Product Change Notification—PCN# **PCN001070**

We would like to inform you that Moxa is going to make changes to the SDS-3008 and SDS-3016 Series. Please review the details below to determine how these changes will affect your products and/or operations.

Current Version	New Version

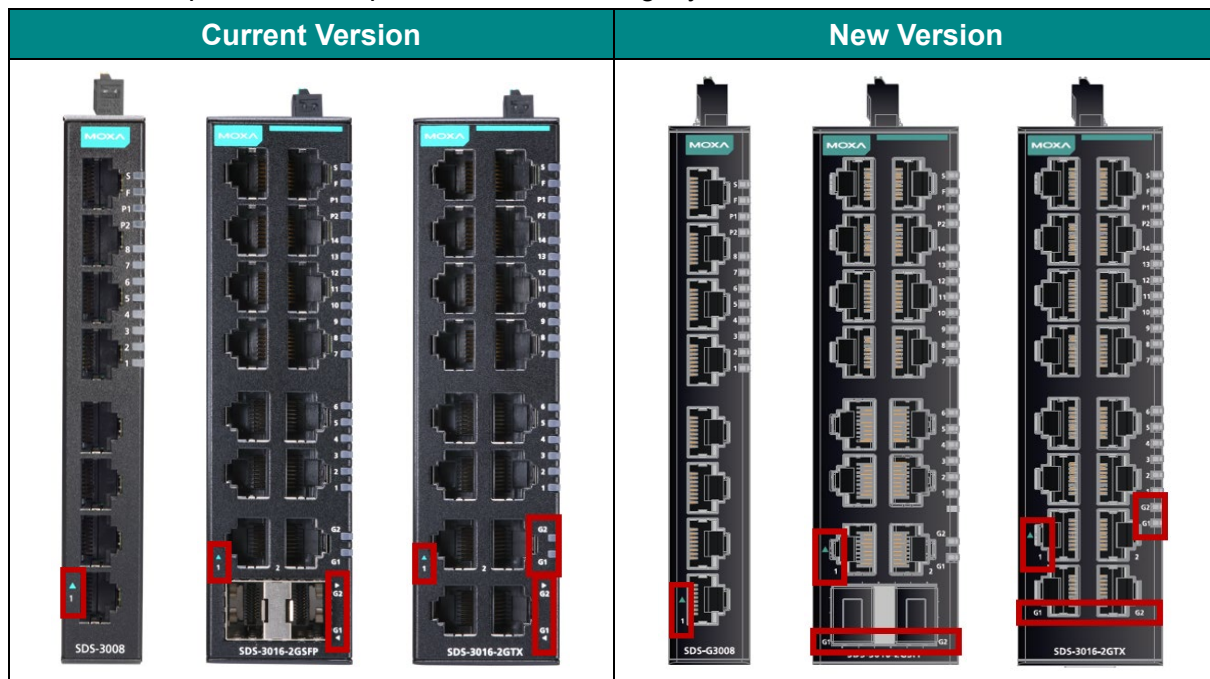
- The rotary DIP switch will be added to the bottom of the SDS-3008 Series to align with the design of the new SDS-3000/G3000 Series and provide an easier configuration option.

- A one-side screw will be added to the terminal block to provide better reliability. The current terminal block is compatible with the new top panel design.
